DRAFT FINDINGS OF FACT REQUEST FOR CERTIFICATE OF APPROPRIATENESS FOR ALTERATIONS VILLAGE REVIEW BOARD

PROJECT NAME: 42 Maine Street, New Café/Bistro Façade

CASE NUMBER: VRB 25-019

REVIEW DATE: August 19, 2025

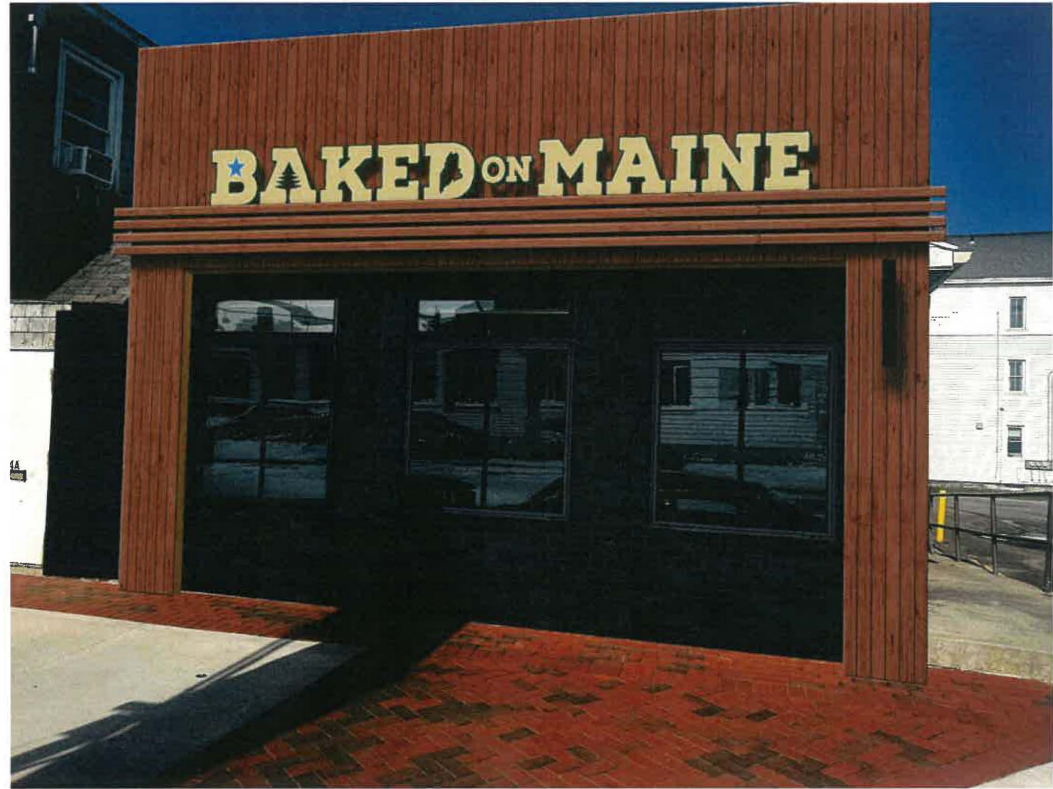
For the three windows on the north face of the building:

Awnings

We are proposing to purchase fabricated standing metal seam awnings.

Awnings are supplied with metal frame supports that will be fastened to the cinder block wall above each window.

Awnings to be of powder-coated metal construction.

Awnings to be 60" wide by 24" tall with a projection of 24" from the wall.

Shutters

12" x 42" Shutters will be custom built and installed on either side of each window.

Shutter material to be natural Wood. Cedar or thermally modified wood.

Proposed Front Elevation Upgrades

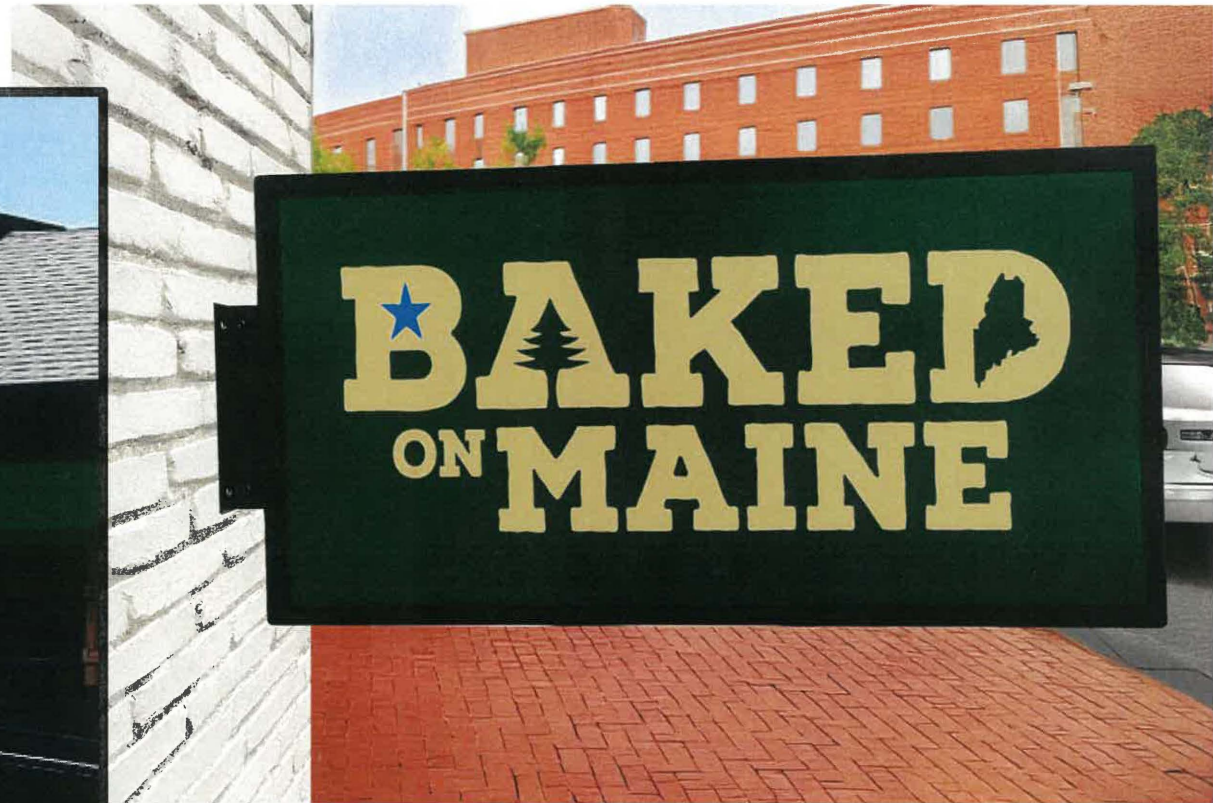
- Possible color treatment to brick.
- Install vertical wood cladding over old façade.
- Install vertical wood cladding on each side of brick face.
- Install horizontal wood cladding at transition right above existing retractable awning.

Proposed North Elevation For Windows & Side Wall

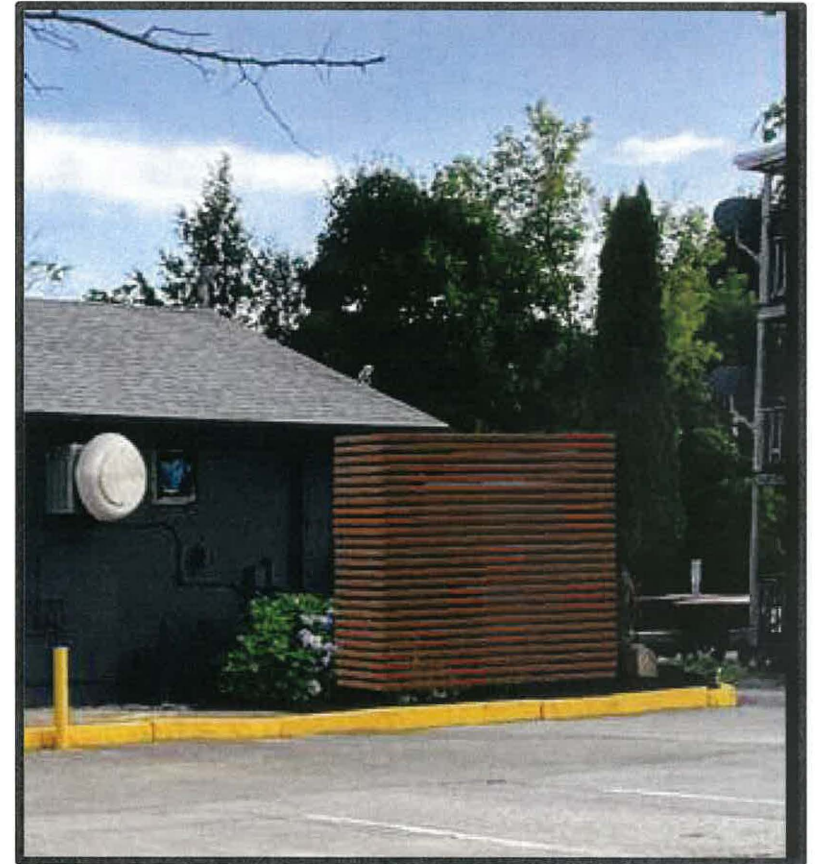
Proposed Upgrades

- Install metal awnings over windows.
- Install wood shutters on the sides of windows.
- Install decorative wood panel to visually break wall length.

**Proposed Wood
Privacy Screen for
Utilities**

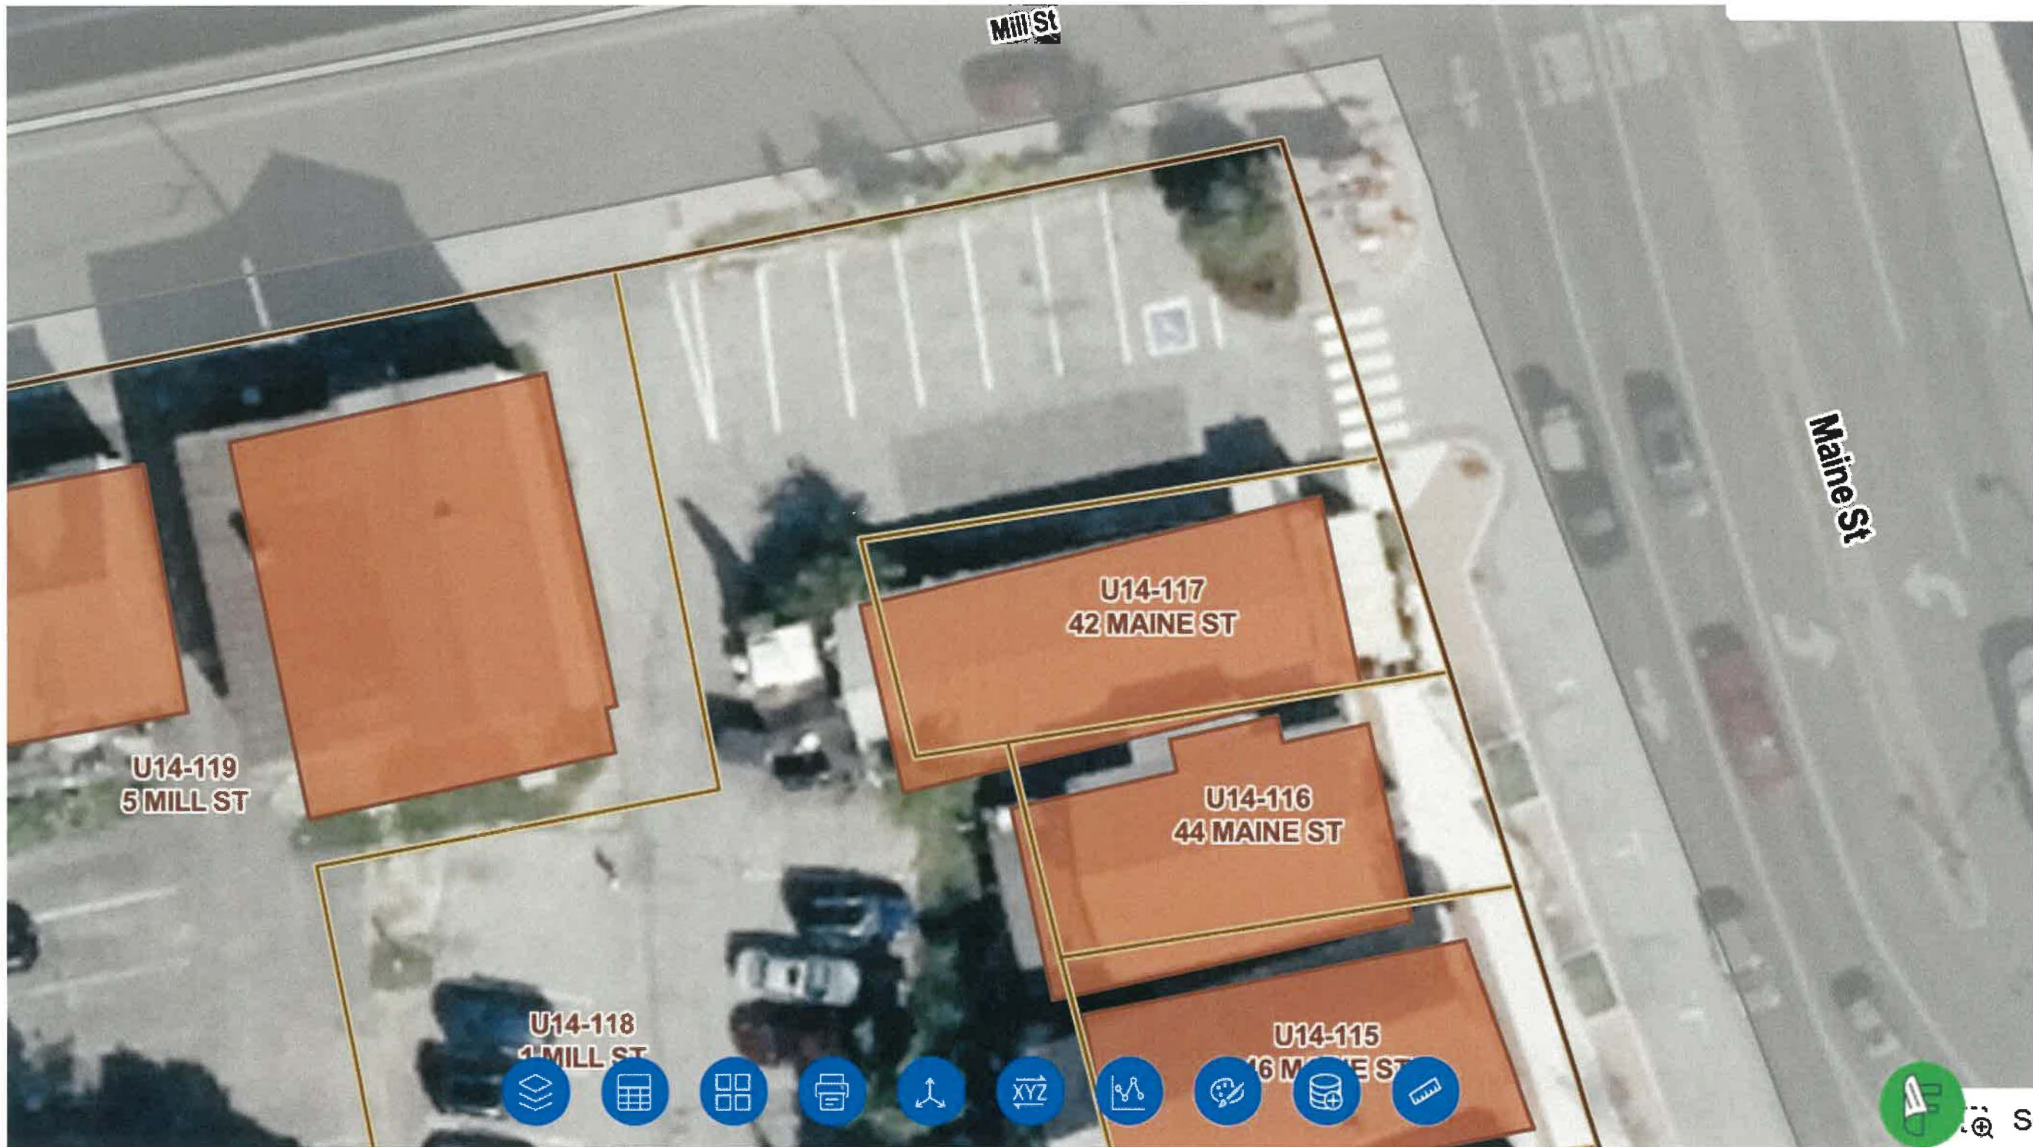
Conceal Walk-In Cooler And
Small Lattice Utility Area
